MEMO

TO: Lashta Haidari, Steven Findlay
FROM: Ody Murlianto, Richard West, Ryan Miller
SUBJECT: Meriton Dee Why Review of Traffic Matters
OUR REF: 2196969A-ITP-MEM-RPT RevA.docx
DATE: 28 March 2017

Northern Beaches Council has engaged WSP | Parsons Brinckerhoff to undertake a review of the Traffic Impact Assessment undertaken to support the Development Application submission for the subject development.

Access Driveway Detail (Traffix, 24 March 2017)

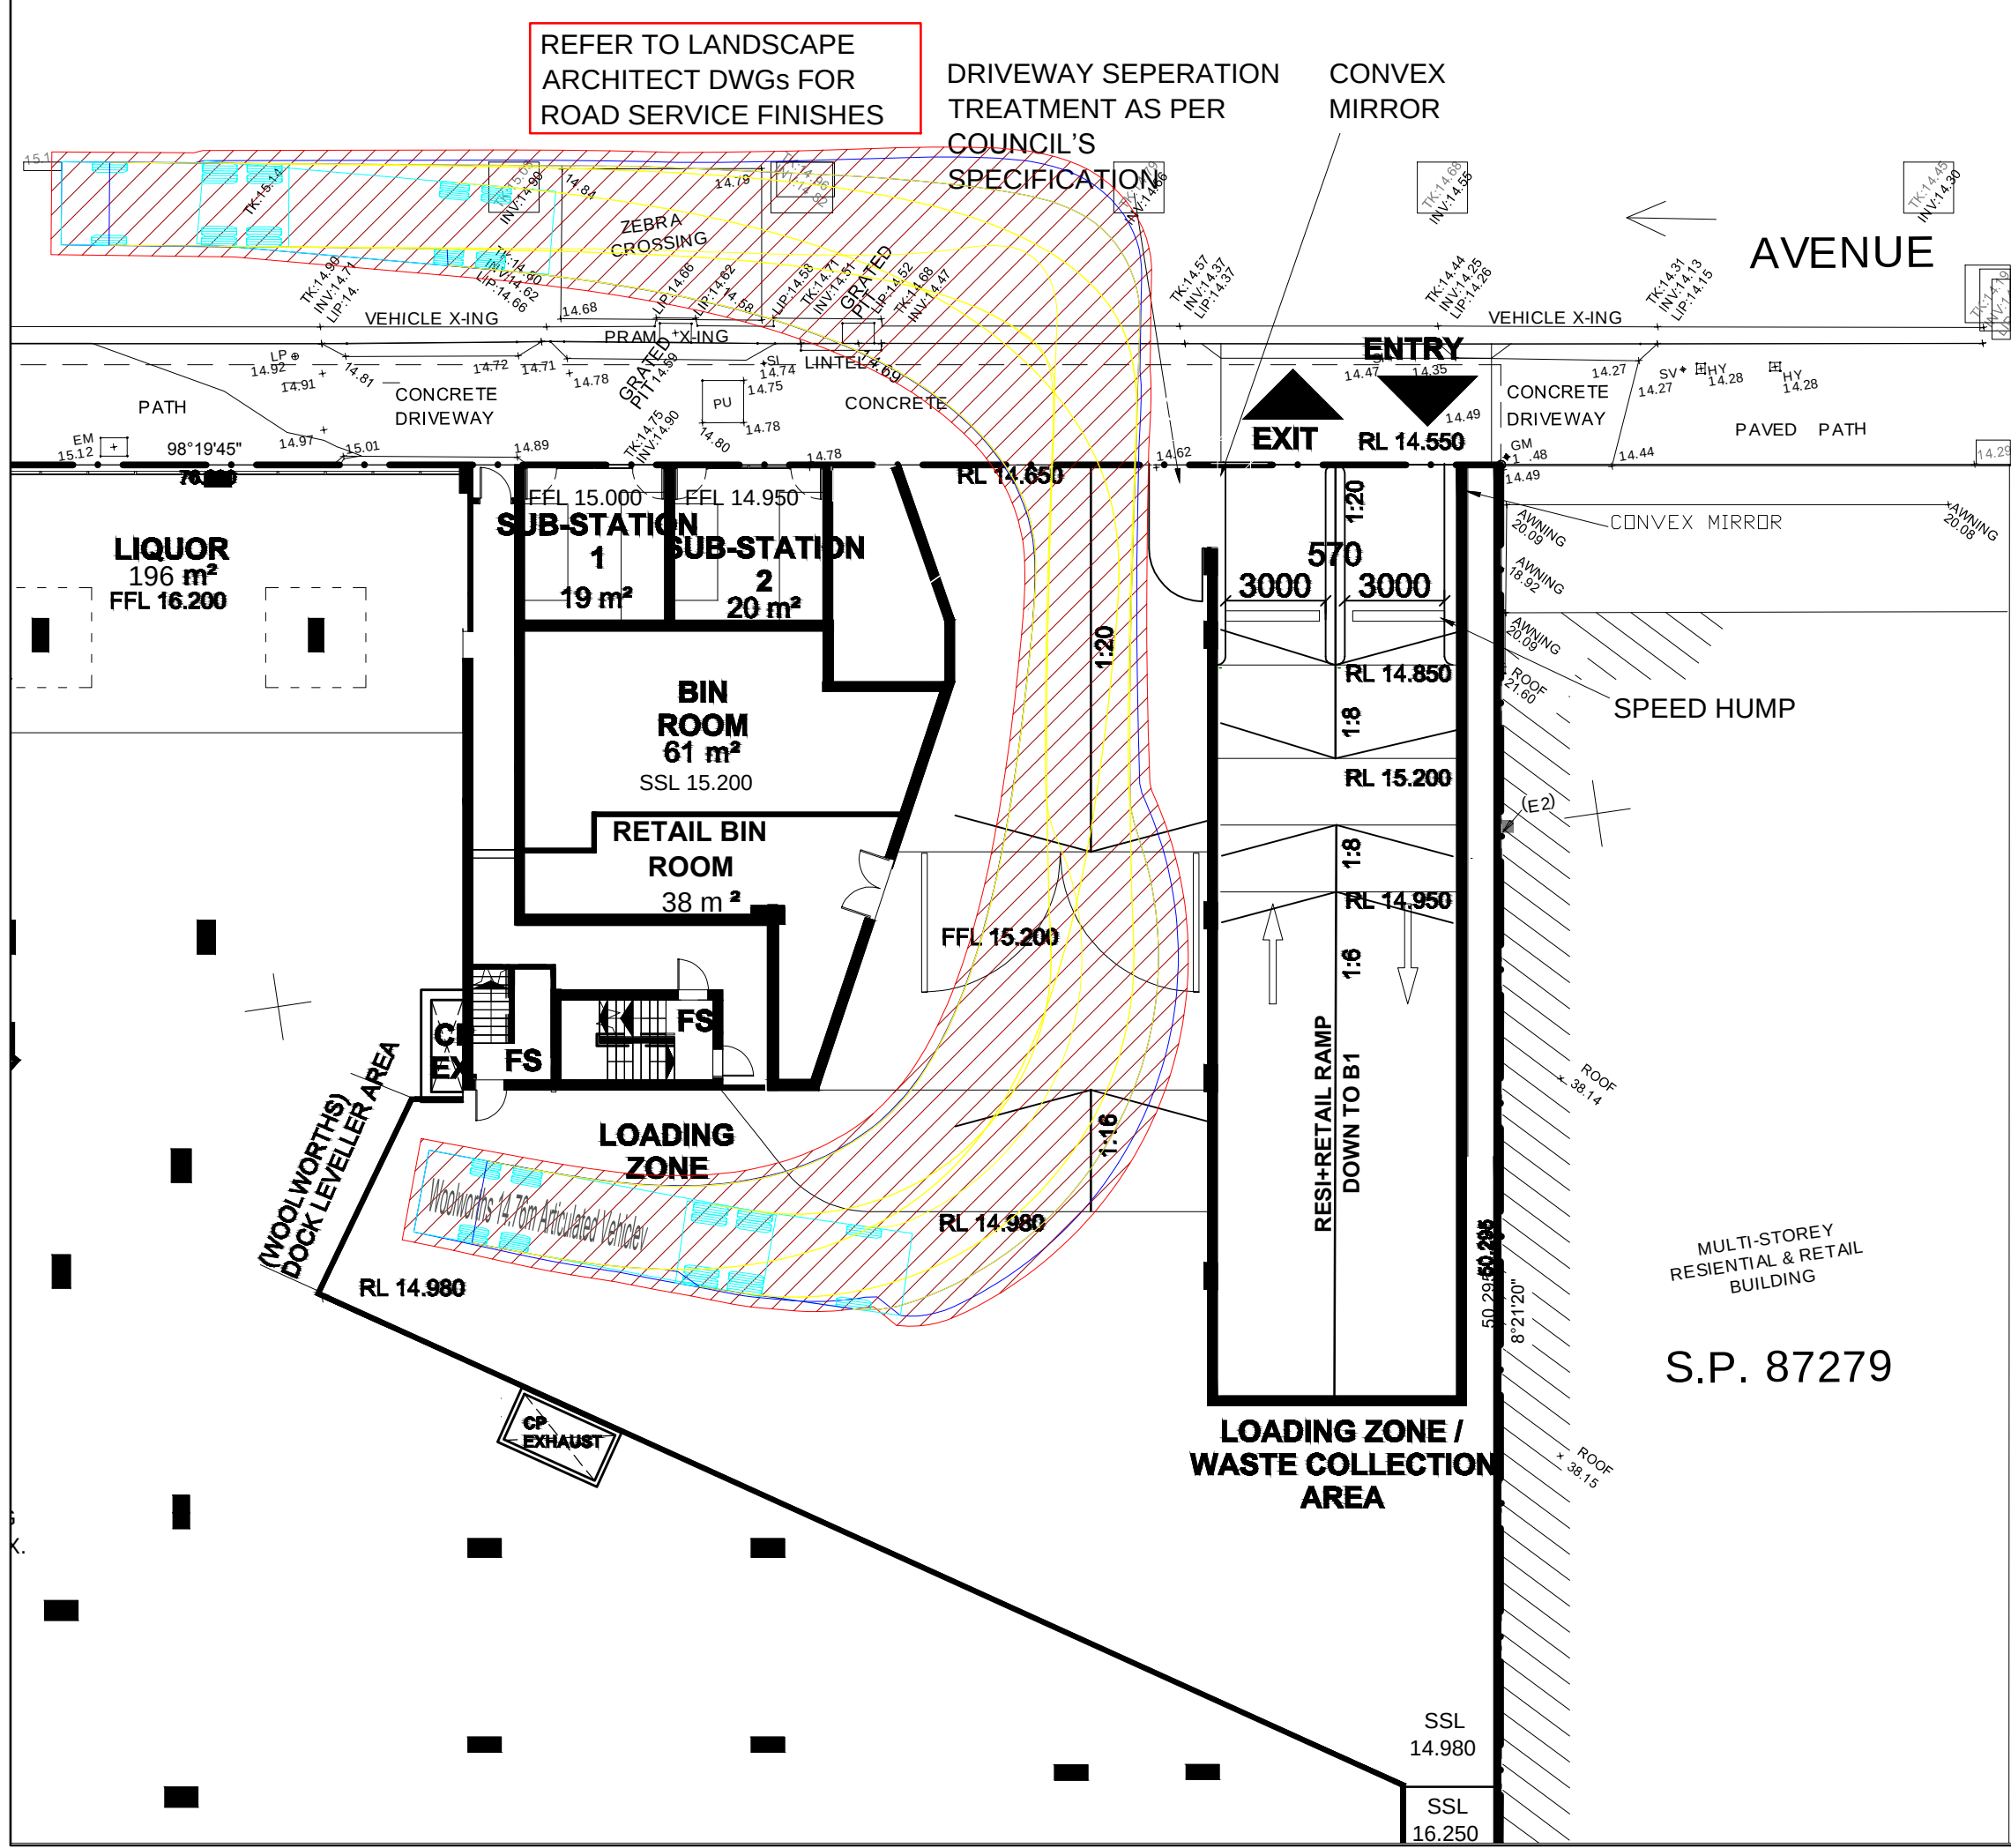
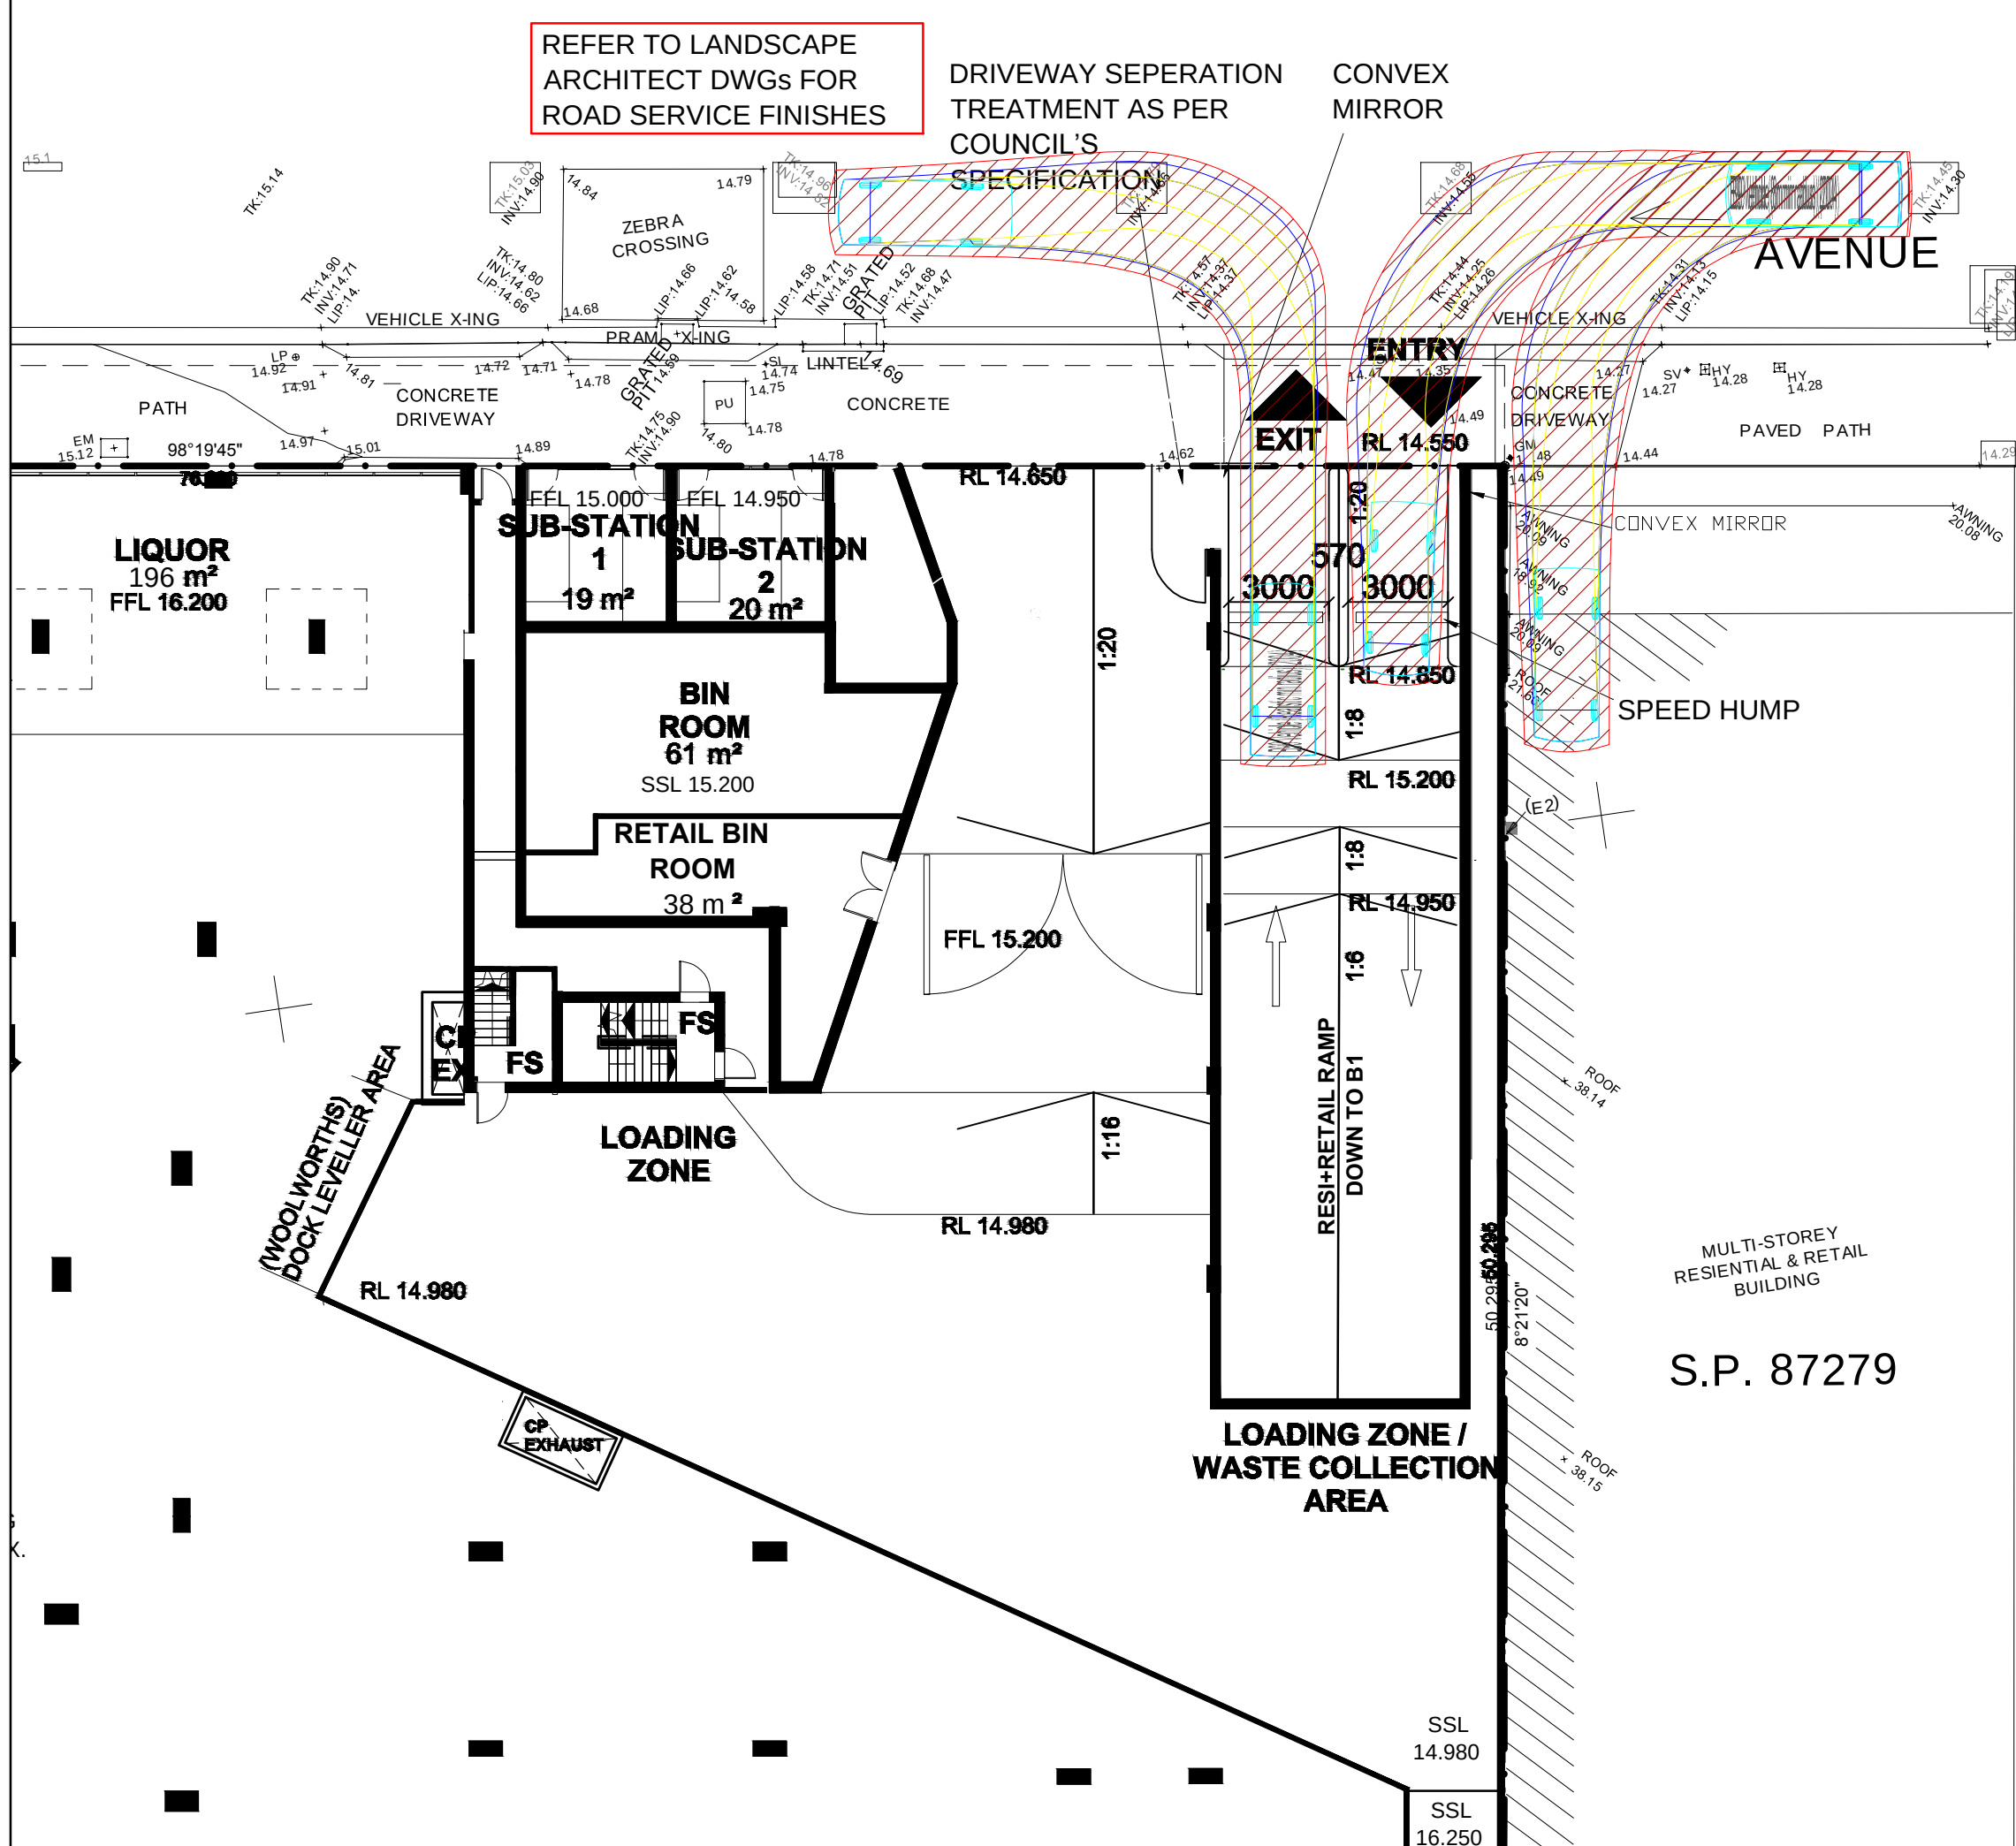
Reviews undertaken on 21 November 2016 and 8 February 2017 raised a pedestrian safety issue associated with the locations of the driveways to the car park, loading dock and neighbouring property's access driveway which would require pedestrians to cross a driveway crossing in excess of 20 metres wide. To put it into perspective, a typical wide collector road is approximately 12.8 metres wide.

It was agreed that to reduce the length of the pedestrian crossing, a driveway separation be installed between the access driveway to the loading dock and the access driveway to the basement car park. The implementation of this treatment was agreed for both driveways at Oaks Avenue and Howard Avenue and are considered satisfactory to achieve the objective of reducing the crossing distance at which pedestrians are required to cross at both access driveways. A copy of the amended drawings and the relevant turning path assessments undertaken by Traffix can be found in Attachment C.

REFER TO LANDSCAPE
ARCHITECT DWGs FOR
ROAD SERVICE FINISHES

DRIVEWAY SEPERATION
TREATMENT AS PER
COUNCIL'S
SPECIFICATION
